COMMONWEALTH OF KENTUCKY
BEFORE THE PUBLIC SERVICE COMMISSION

THE APPLICATION OF BARKLEY LAKE WATER)	
DISTRICT, (1) FOR A CERTIFICATE THAT)	
PUBLIC CONVENIENCE AND NECESSITY RE-)	
QUIRES THE CONSTRUCTION OF NEW PLANT)	
FACILITIES; AND (2) SEEKING APPROVAL)	CASE NO.
OF THE ISSUANCE OF CERTAIN SECURITIES;)	8937
AND (3) FOR AN ORDER AUTHORIZING AD-)	
JUSTMENT OF WATER SERVICE RATES AND)	
CHARGES)

R E P O R T

RE: Case No. 8937
Review of the engineering hydraulics submitted
by Barkley Lake Water District

FIGURE 1

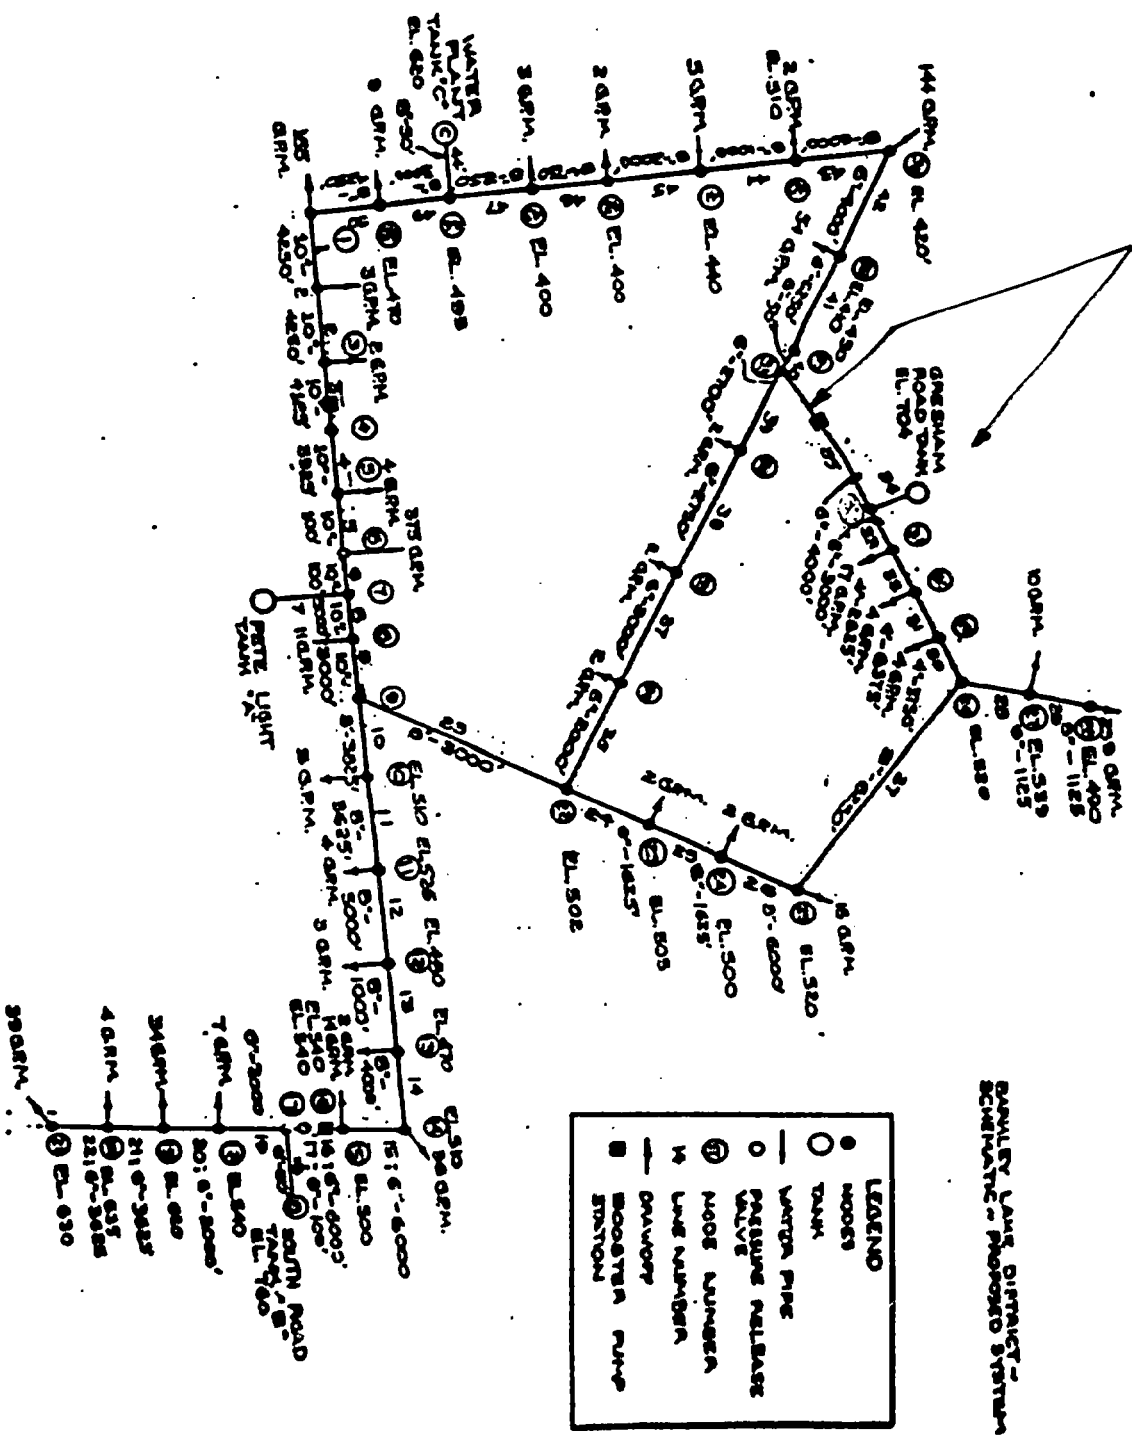
distribution system includes a water treatment plant, 4 storage tanks, and about 286 miles of pipeline (See Figure 1). The 4 storage tanks: a 250,000-gallon elevated tank at the water treatment plant, a 200,000-gallon standpipe near Pete Light Springs Road, a 150,000-gallon storage tank near Cerulean and a 50,000-gallon elevated storage tank near South Road provide a total of 650,000 gallons of storage. However, after subtracting the minimum tank level requirements, we find that only 420,000 gallons of this storage can be considered as useful storage. Water in storage below minimum levels will not provide minimum requirements for service pressure.
